Historic Saranac Lake – Trudeau Building Phase 1 Exterior Restoration Project

Issue Date: 23 April 2021

ADDENDUM #2

Portion of Sheet A2.06

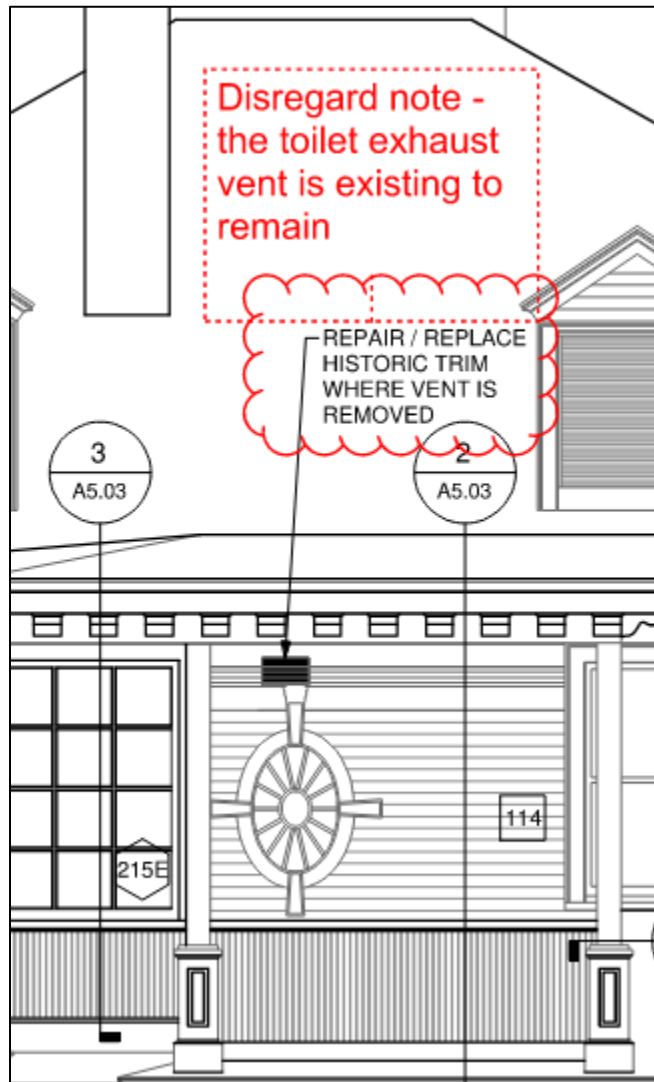
Item #3	Question 3	<p>Question: On A2.06, there is a note on the west wall that says “see structural drawings”. There appears to be no work here on the structural drawings.</p> <p>Answer: The note on A2.06 is incorrect. See attachment 1.</p>

Item #3, Question #3, Attachment 1

Portion of Sheet A3.02 – West Elevation 2 / A3.02

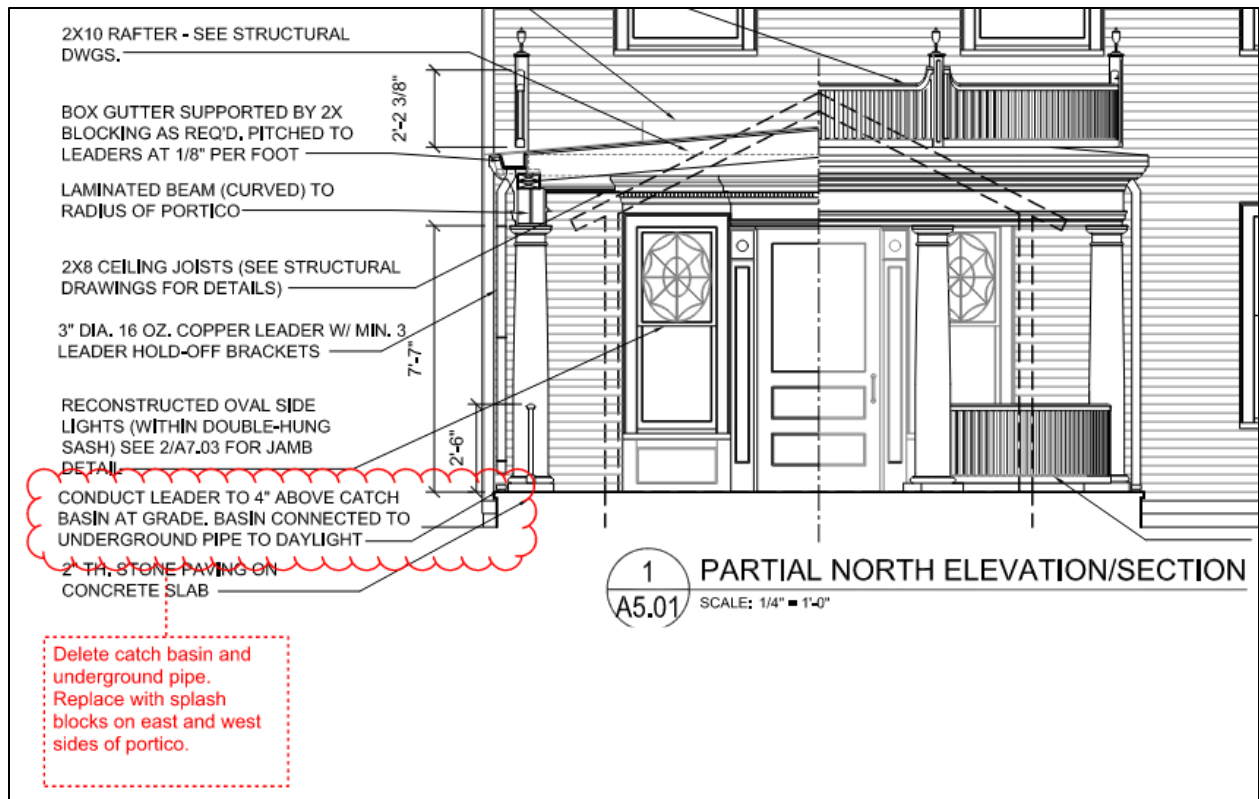
| Item #8 | Toilet exhaust fan at Cure Porch 215 | The toilet exhaust vent shown in Demo note D111 on sheet A2.02 and shown on West Elevation 2 on sheet A3.02 is existing and will remain. There is no work scope associated with this item. See item 8, Attachment 2. |

Item 8, Attachment 2

1 SITE PLAN
A1.03
SCALE: 1" = 10'-0"

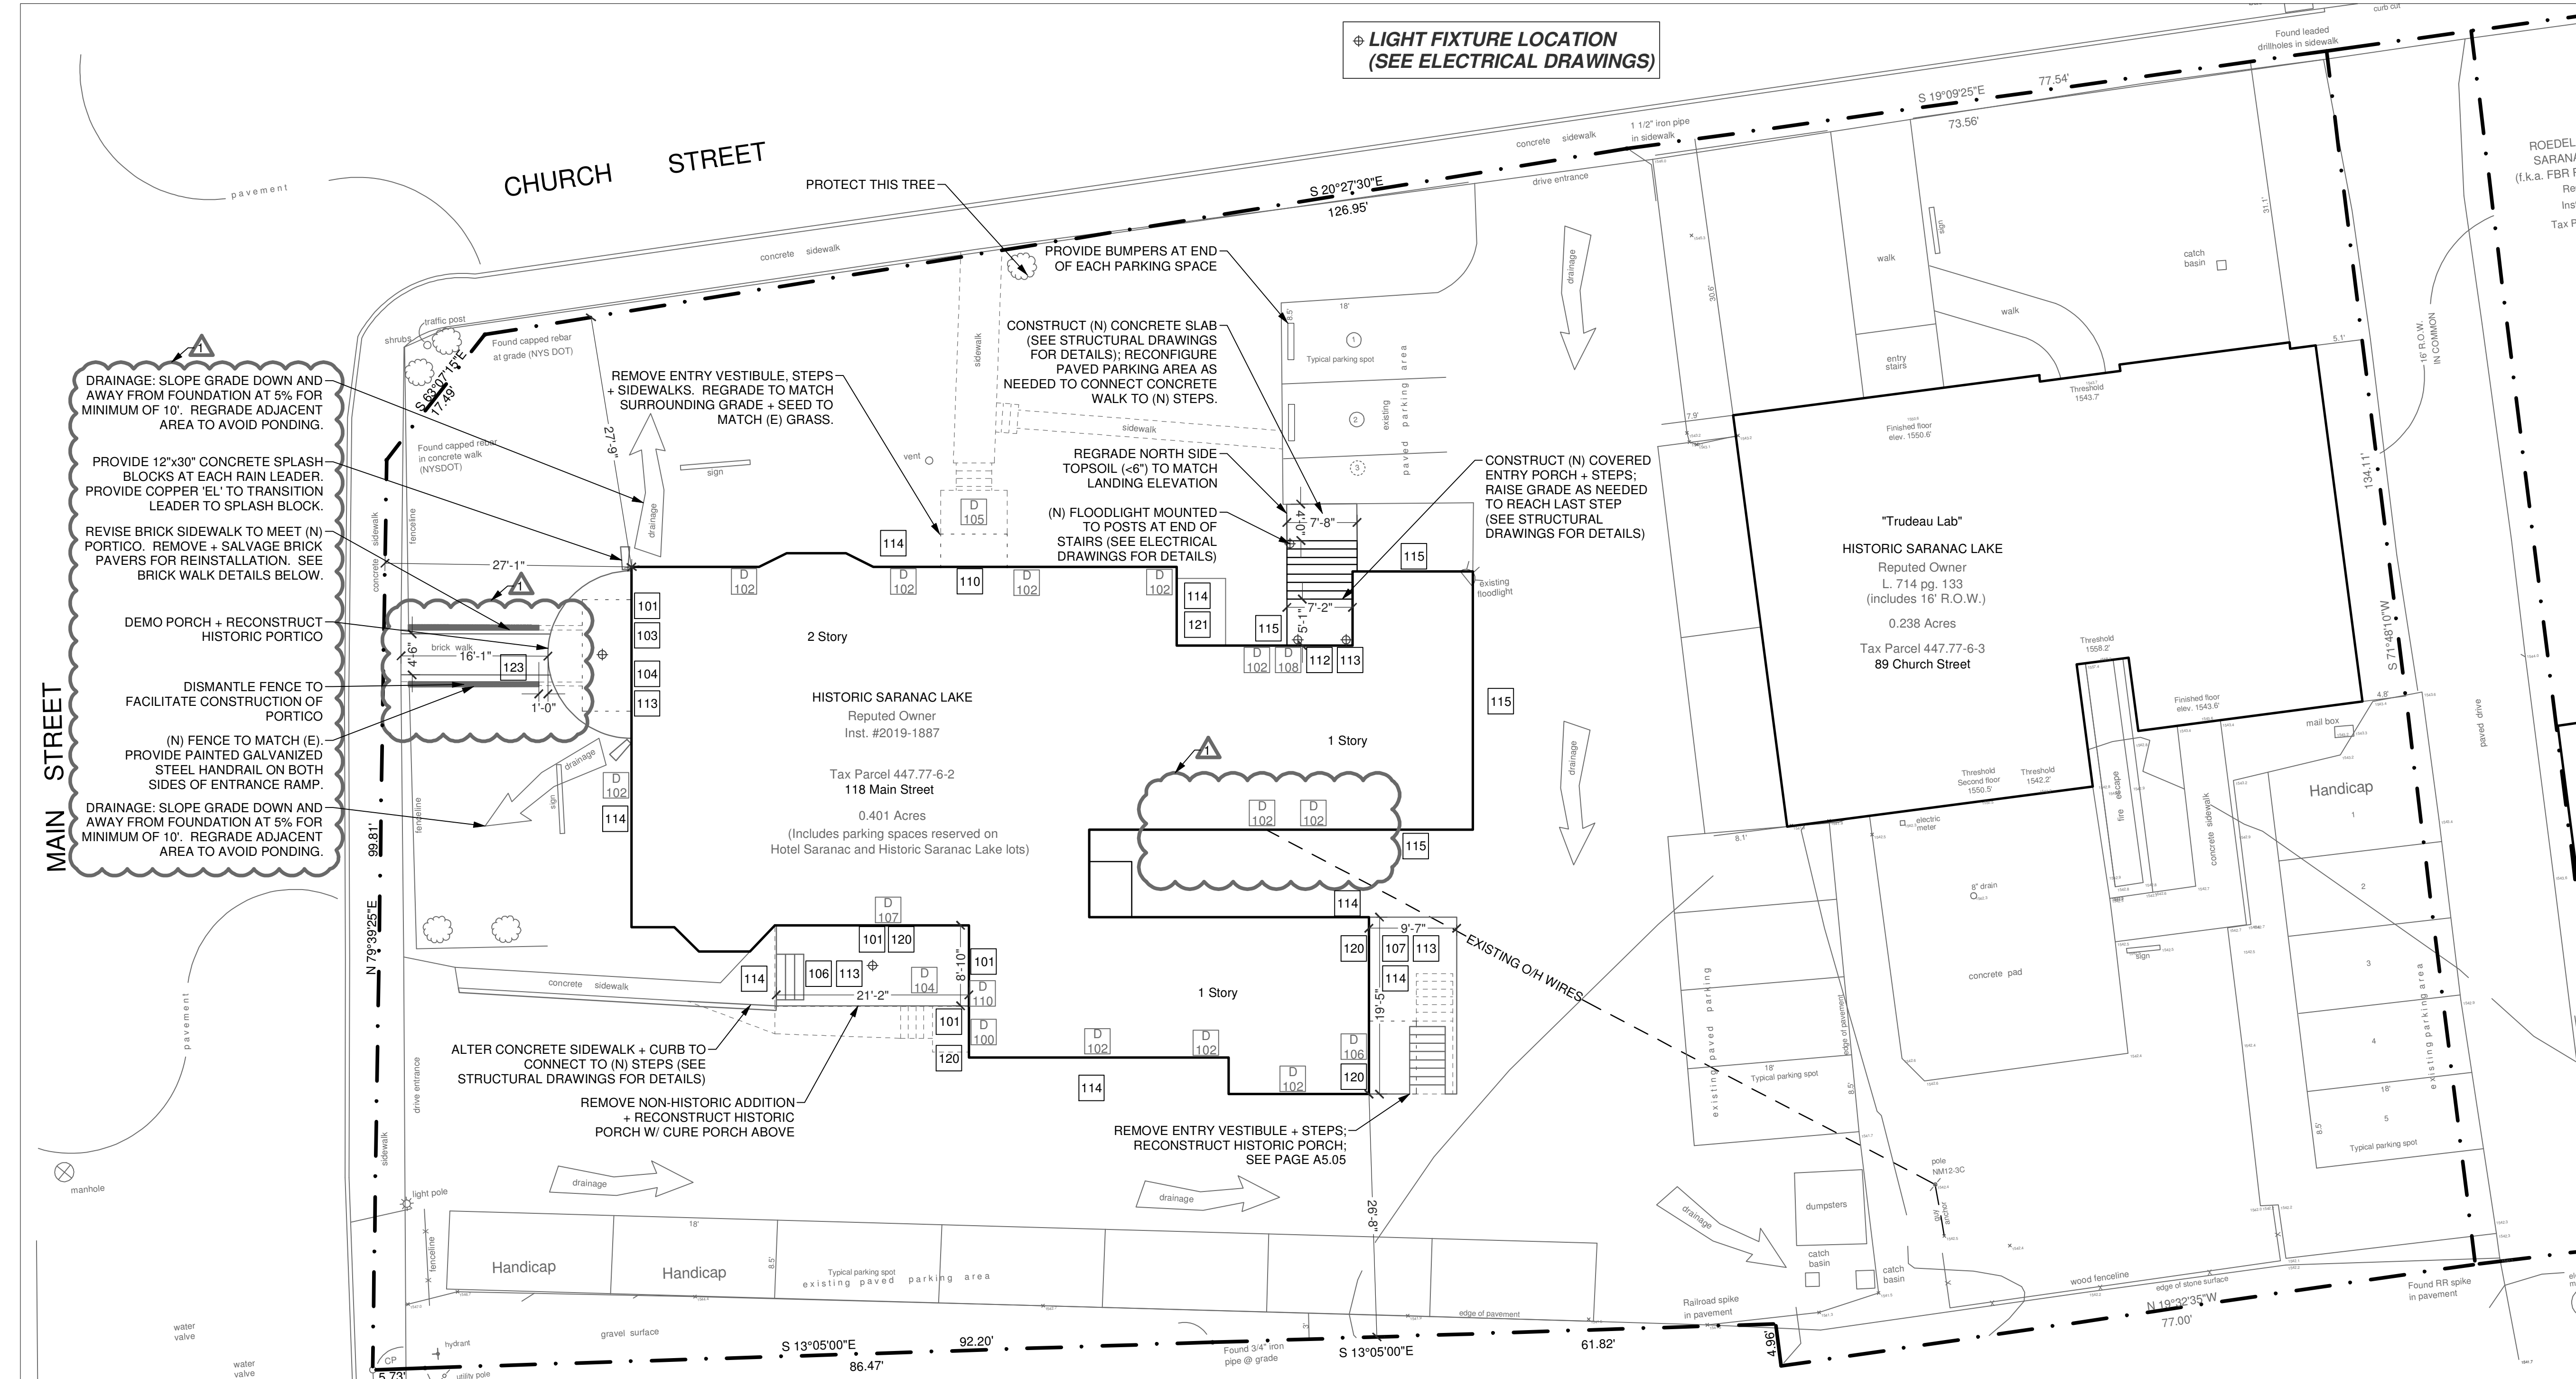
Item #4	Removal of Trees	<p>On Site Plan A1.03, the Contractor is instructed to remove Cedar Trees, a Maple Tree, a Spruce Tree, and a Lilac Bush that are adjacent to the North and East sides of the building. This tree removal work will be accomplished by HSL prior to the commencement of general construction. This work is no longer in the scope of work of this general construction contract.</p> <p>The Contractor is advised that some below-grade roots may be encountered during the construction of the North Portico (123) and other exterior elements. Removal of these roots, if required for this construction, is the responsibility of the Contractor as part of the scope of work of this general construction contract.</p>

Item #5	Site Plan A1.03 Re-issued 04.23.21	<p>Site Plan A1.03 has incorrect numeric and graphic scales. The corrected A1.03 dated 04.23.21 is issued in this Addendum to replace A1.03 dated 04.02.21. The brick walkway to the new portico on Main Street has been revised. Some other minor changes are included in the revised A1.03 and are shown in bubbles.</p>

| Item #9 | North Portico | On sheet A5.01, Elevation/Section 1 / A5.01, the proposed catch basin and underground pipe at the bottom of the rain leader is eliminated and is replaced with a 12" x 30" concrete splash block on both the east and west sides of the new portico. Provide copper "EI" fitting at bottom of each rain leader to transition to splash block. See Site Plan A1.03. See item 9, Attachment 3. |

121	REFINISH + REPAINT METAL HATCHWAY DOORS; REMOVE + REPLACE STAIRS; REPAIR SKIRT BOARD DIRECTLY ABOVE
122	INFILL WALL OPENING - SEE DETAIL SHEET A3.05 (AC UNITS ARE APPROX 1'-0" W x 1'-2" TALL - VIF)
123	REVISE ON-GRADE WALKWAY TO CONNECT TO (N) PORTICO STONE FLOOR
